MID SUSSEX DISTRICT COUNCIL

DM/21/2628

**LAND TO THE REAR OF FRIARS OAK LONDON ROAD HAS SOCKS
WEST SUSSEX**

**RESERVED MATTERS APPLICATION FOR THE APPROVAL OF
APPEARANCE, LANDSCAPING, LAYOUT AND SCALE AT LAND R/O
FRIARS OAK PURSUANT TO OUTLINE PLANNING PERMISSION
DM/19/1897, COMPRISING OF A RESIDENTIAL DEVELOPMENT OF 130
DWELLINGS AND ASSOCIATED ACCESS TOGETHER WITH CHANGE OF
USE OF PART OF THE LAND TO COUNTRY OPEN SPACE, FOLLOWING
THE PROVISION OF A NEW PEDESTRIAN TUNNEL UNDER THE
RAILWAY. (ADDITIONAL BIODIVERSITY REPORT AND ENERGY
STRATEGY REPORT RECEIVED 31 JANUARY AND 1 FEBRUARY.)**

(Mapping reproduced from or based upon 2021 Ordnance Survey material, WSCC licence 100023447. Rights of Way information is not definitive).

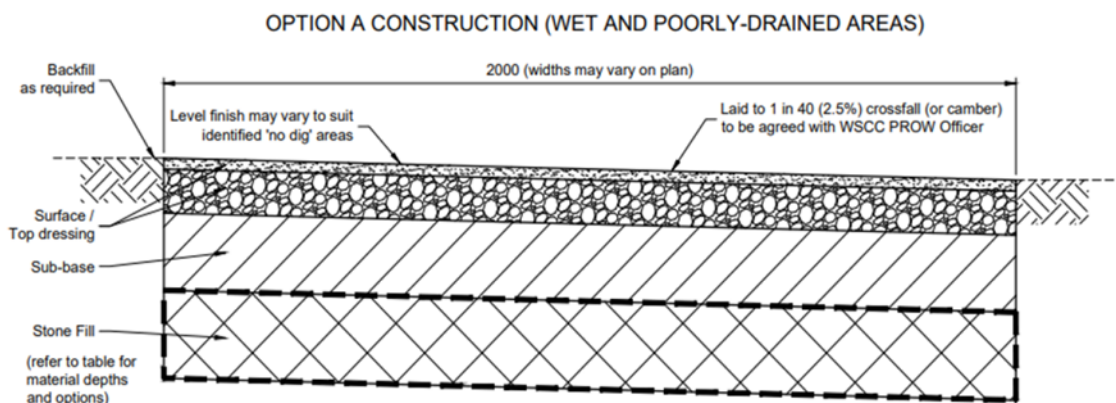
Regards surfacing, I note the diverted route of the Footpath will partially follow an adopted road, then you propose it becomes block-paved, after which I'm not able to define how it will be surfaced. The plans refer to 'Existing public footpath retained'. Once the Footpath leaves the adopted road, all surfaces must be agreed by the Public Rights of Way team at West Sussex County Council. Please clarify how you propose to surface the Public Right of Way after the block paved section.

Finally, as stated in my previous response, with the upgrading of Footpath 5K to Bridleway status east of the railway crossing under the Clayton Mills development and the construction of the new railway subway being to a height and width that allows for horses to pass through, I am keen to ensure that all new residents of this and adjacent sites and all potential users of the path will be able to use the section of Footpath 5K that runs through this site. Whilst no condition has been placed on the developer to upgrade Footpath 5K to a Bridleway, there is still the opportunity to do so, or at least, with the landowner's permission to make this path a Permissive Bridleway. The connections this would facilitate would be positive, wide-ranging and create the continuity much needed in the network. Should the path be constructed to a minimum 3m width, the only further consideration is the surfacing. A willingness to consider this would be greatly appreciated.
